From: Quinn, Laura
Sent: Tuesday, November 02, 2010 4:47 PM
To: Kropp, Roy K; Nash, Harriet
Cc: Parkhurst, Mary Ann; Lopas, Sarah
Subject: FYI Letter from Corps to UniStar requesting responses to DEIS/Public Notice comments
Attachments: ML1030202643.pdf

This is in reference to Department of the Army permit application CENAB-OP-RMS (CALVERT CLIFFS 3 NUCLEAR PROJECT, LLC/UNISTAR NUCLEAR OPERATIONS SERVICES, LLC)2007-08123-M01 to perform site preparation activities and construction supporting facilities at the site of a proposed nominal generation station (Unit #3) at Calvert Cliffs, Calvert County, Maryland.

RE: Comments on CCNPP Unit 3 FSAR Rev 6 Section 2.5 "Geology, Seismology, and Geotechnical Engineering"

Encl 1 – Gernant's Fig 4, page 10 of 1970 Maryland Geological Survey,
Report of Investigations No. 12:

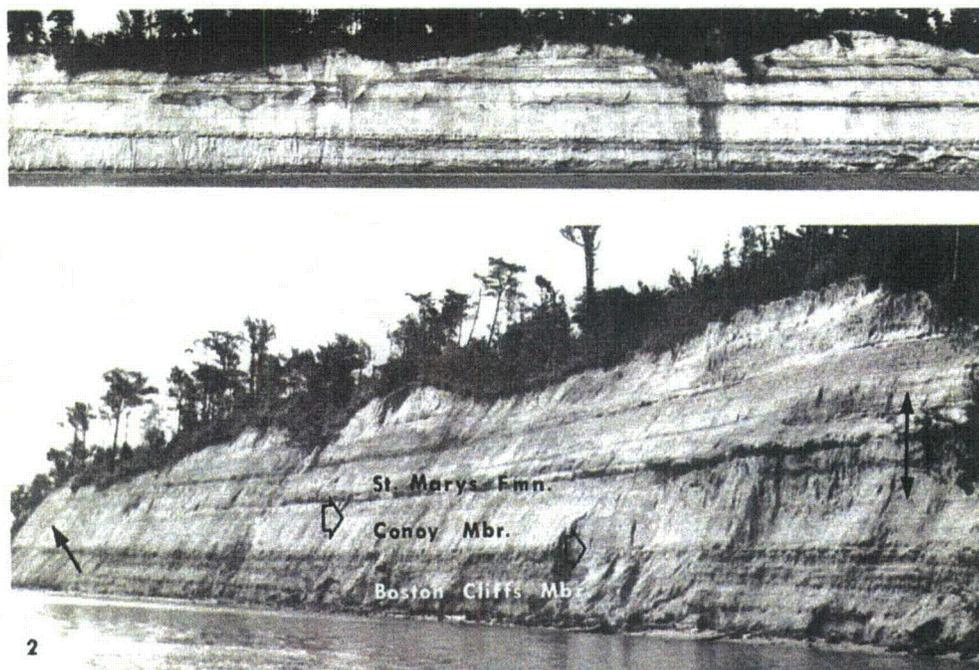
Concerning the apparent lack of other published observations on structural warping (p. 2-1118), Gernant (1970, Maryland Geological Survey, Report of Investigations No. 12) also detected the notable change in dip of Miocene strata within the Conoy Cliffs and also attributed it to folding (see Encl 1: Gernant’s Figure 4, p.10, included below). This is one published paper missed in the FSAR review, albeit directly relevant. [The one outcrop photograph provided in the FSAR (Fig. 2.5-44) is a highly oblique view of the same Conoy Cliffs, taken from a large distance, that will minimize the viewers ability to appreciate the feature. It concerns me that this might have been the only perspective FSAR authors had, other than perhaps a highly foreshortened view from the narrow beach at the base of the Conoy Cliffs.] Genant and I both recognized the involvement of folding in the creation of the reversed dip of Choptank Formation beds within the Conoy Cliffs, despite the erosional nature of the stratigraphic discontinuity surface(s) that define those beds. (Paleo)erosion is commonly localized in areas of relative uplift (regardless of whether uplift is antecedent/inherited, syn-depositional, or post-depositional). The erosional nature of some of the bed contacts that Gernant and I traced is thus not mutually exclusive with the existence of structural warping as a contributing – or even a primary – control on observed changes in bed elevation, contrary to the implication of the FSAR (e.g.. p. 2-1095, “undulations typically represent erosional features...”). My 1997 paper is explicit that, although some variation in elevation of beds (more precisely, discontinuity surfaces) within the larger Calvert Cliffs are entirely erosional in nature (representing incised channels), changes in elevation near the CCNPP and some others appear to instead be structural warps, at least in part (1997 JSR paper, p. 324). That assessment reflects an explicit rejection of the hypothesis of erosion. In fact the lack of any sedimentary response to the relative (paleo)high on the south side of Moran Landing– St Marys beds do not thin or become coarser over it -- argues that the offset in elevation here is post-depositional (notice the continuity of facies tracts within SM units that can be traced across the postulated fault plane in my 1997 cross-section). The FSAR authors seem to be broadly skeptical of changes in bed elevation as evidence of structural features (e.g., in also rejecting McCartan and others’ postulated monoclines, p. 2-1093, -1095, -1116, -1199, etc.) and to be unattuned to using sedimentologic/ stratigraphic evidence for growth faulting and folding. I, too, would not use it as definitive evidence. However, I would expect an explicit testing of faults hypothesized on this basis using more definitive methods (dedicated boreholes, trenches, seismic profiling) before rejecting it, especially when placement of a public facility was an issue.

7. (**Sevilla Exhibit 7**) Dr. Robert Gernant, in the 1970 publication of the Maryland Geological survey, “Report of Investigations No, 12”, page 10, Figure 4, published his picture of Calvert Cliffs at “Camp Conoy, YMCA” because he noticed the unusual tilt of the beds in that area of Calvert Cliffs. Dr Gernant’s picture is the north cliff view of the same area labeled by Dr. Kidwell in her 1997 JSR study, page 324, Figure 2, as “Conoy Landing”(Sevilla Exhibits 5 and 6).

Encl 2a – Sevilla Exhibit # 4, PSC CPCN Case No. 9218 testimony – Kidwell:

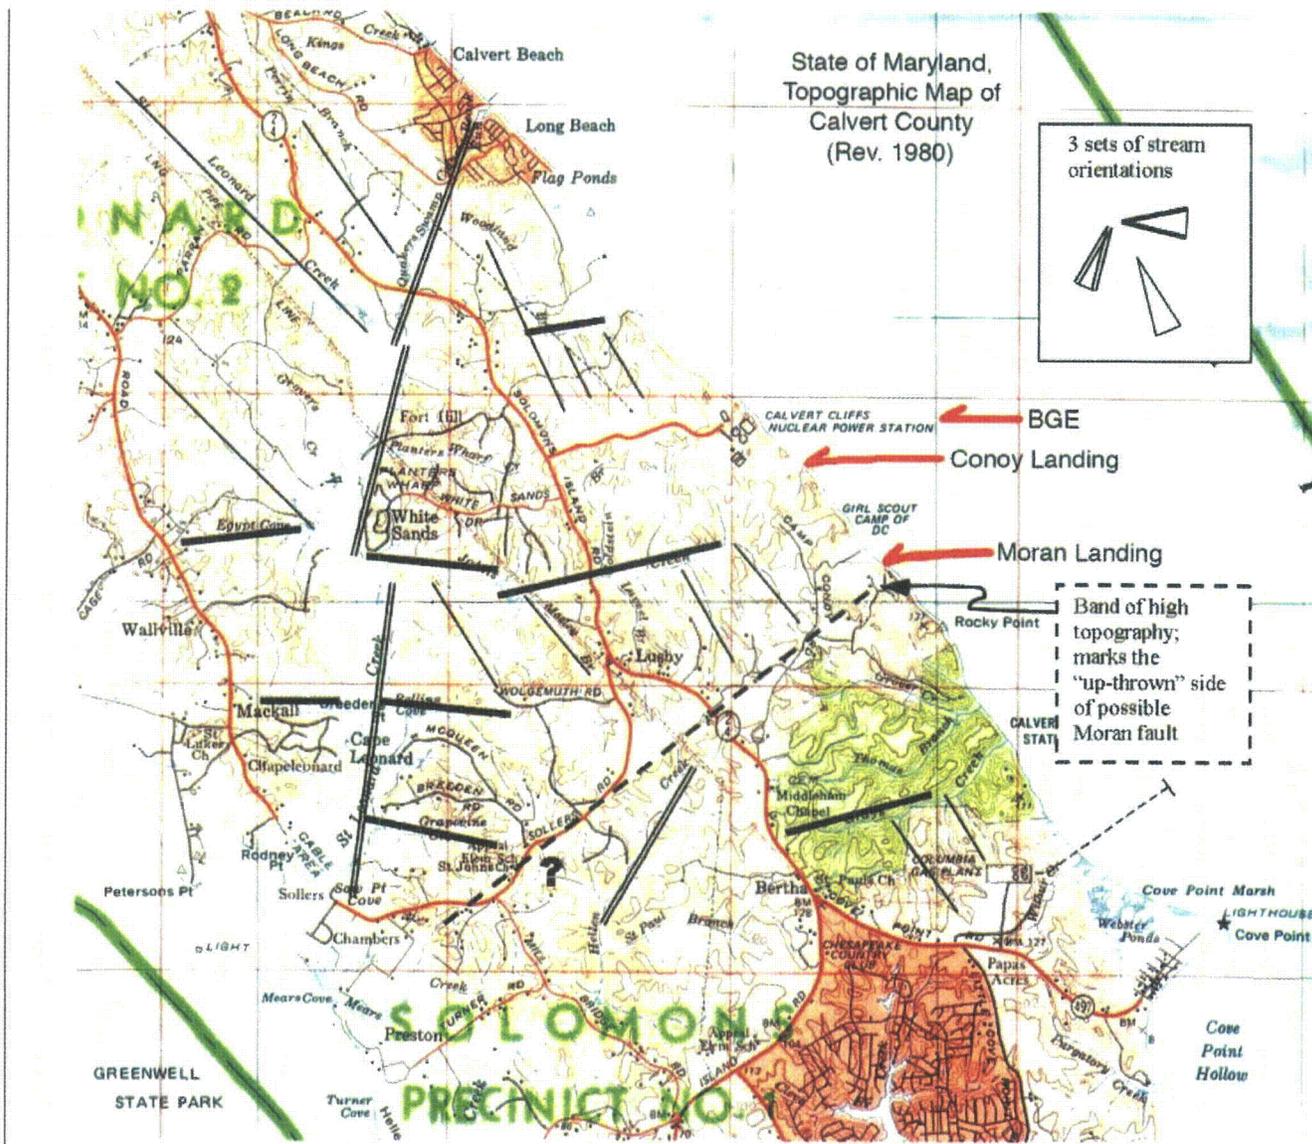
1. Many streams have suspiciously long straight stretches and make approximately right-angled turns, which is typical of terrains where there is an underlying structural (tectonic) control on drainage.
2. This contrasts with the "dendritic" (root-like) pattern that typifies terrains lacking any structural control on the weakness of the underlying rocks.

5. The bold dashed line on the map, running Northeast - Southwest, marks a band of topographically high land that extends from the Calvert Cliffs over to the Patuxent River:

- c. This dashed line does not mark the trace of the postulated Moran Fault, but rather the topographic high running land along the edge of the "up-thrown" block. The fault line would be located on the north side of this dashed line within the order of a quarter mile.

6. The location of the CCNPP Unit 3 Cooling Tower, when measured relative to the dashed line is about a half mile northwest of the dashed line; even lying closer to the postulated Moran Landing Fault (less than a half mile).

Dr. Peter Vogt's analysis of Dr. Susan Kidwell's 1997 JSR paper, Figure 2, page 324 of the international publication.

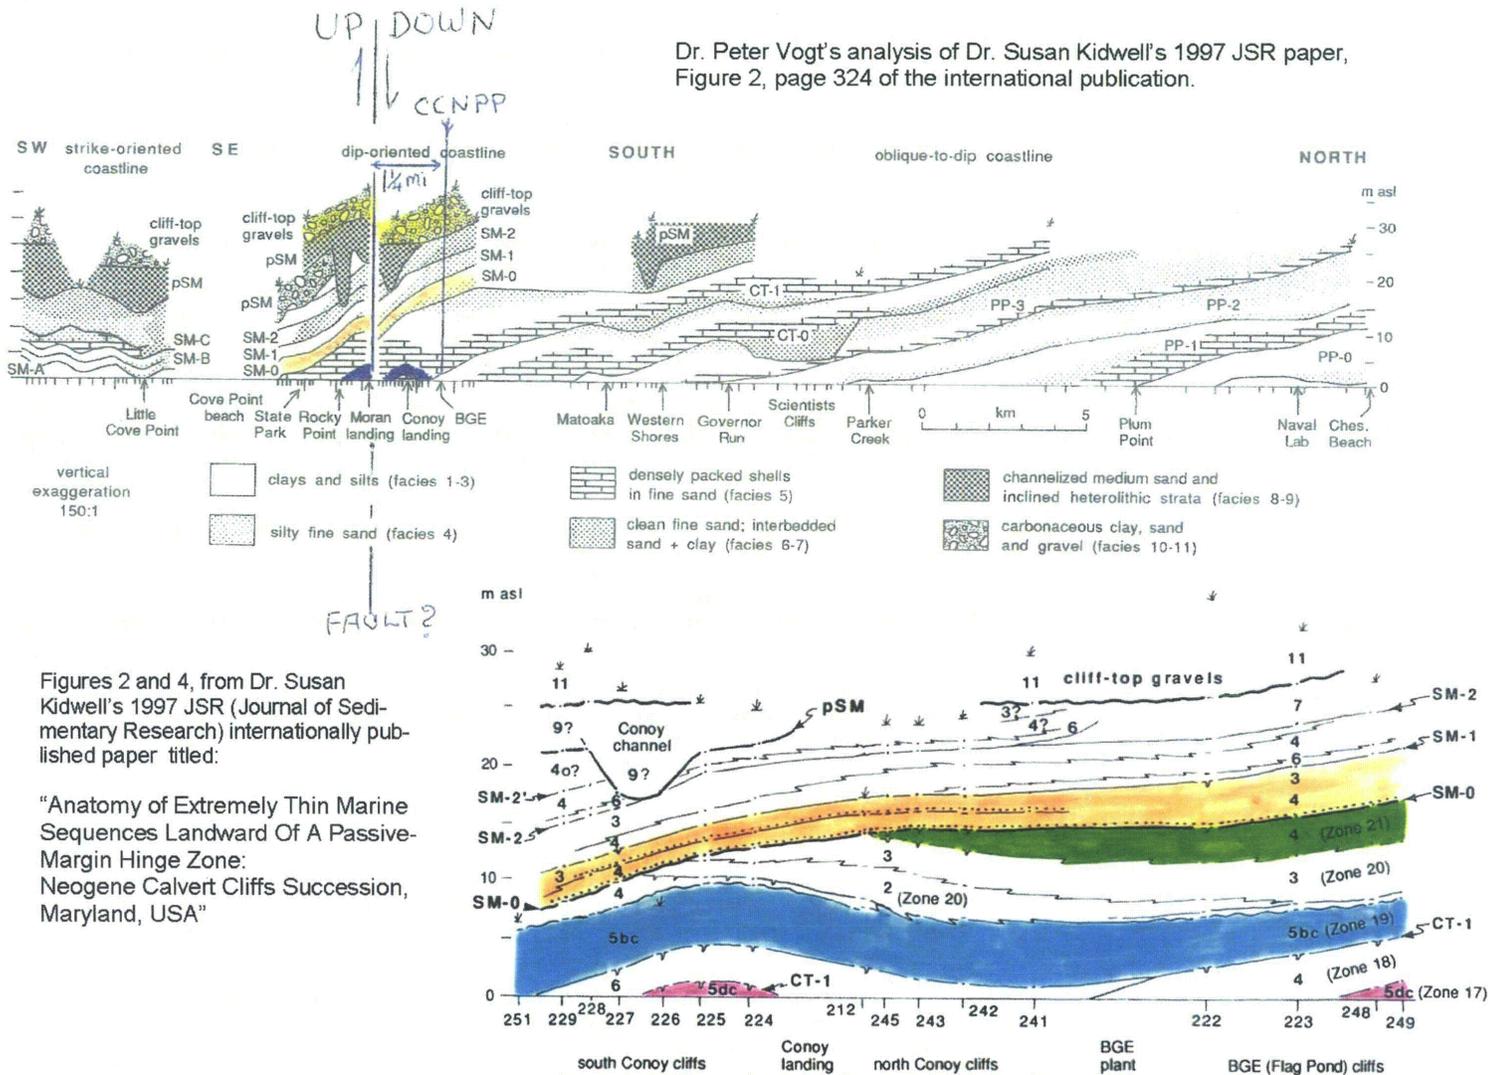
9. There are thus 3 kinds of evidence suggesting a plausible fault: a) contrast in elevation of beds between north and south sides of “Moran Landing” (underscored in Dr. Vogt’s mark-up of Dr. Kidwell’s 1997 Fig. 2; b) arching of beds at Conoy Cliff, as diagramed in Kidwell’s Figure 2 and as evident in part of Dr. Gernant’s Figure 4 in 1970; and c) unpublished 2010 observation by Drs. Kidwell and Vogt of the topographic features as suggested by the line of topographically high land and orientation of the streams as corroborated in part by Dr. Larsen (page 1 this Sevilla Exhibit 4).

A. They show various cross-sectional views of the Calvert Cliffs – that is, they are diagrams of what you would see if you were standing slightly offshore on the Bay and looking at the Cliff face. The illustration at the top half of the page is a colored version of the same Figure 2 on page 324 of my JSR paper, marked up by a respected colleague, Dr. Peter Vogt. Dr Vogt and I discussed the fault location personally and I concur that he has the trace of the possible fault located correctly, at Moran Landing, with the correct motion of blocks on either side, and has the CCNPP correctly positioned at my label BGE. Dr. Vogt has “darkened” in a bed at the base of the CT-1 sequence, which obscures the pattern denoting sedimentary type for that bed, but this ”darkening” was to accentuate the features supporting the fault interpretation. Figure 4 is simply a more detailed view of bed relations north (part B) and south (part A) of Moran Landing.

A. What's suspicious is that sedimentary layers measured in cliffs on the south side of this gap in the topography appear to be at a higher elevation in cliffs on the north point side of the low area. All of the beds seem to be offset upward, which suggests later structural modification, such as a fault where rocks on the southern side are "up-thrown" relative to those on the northern side.
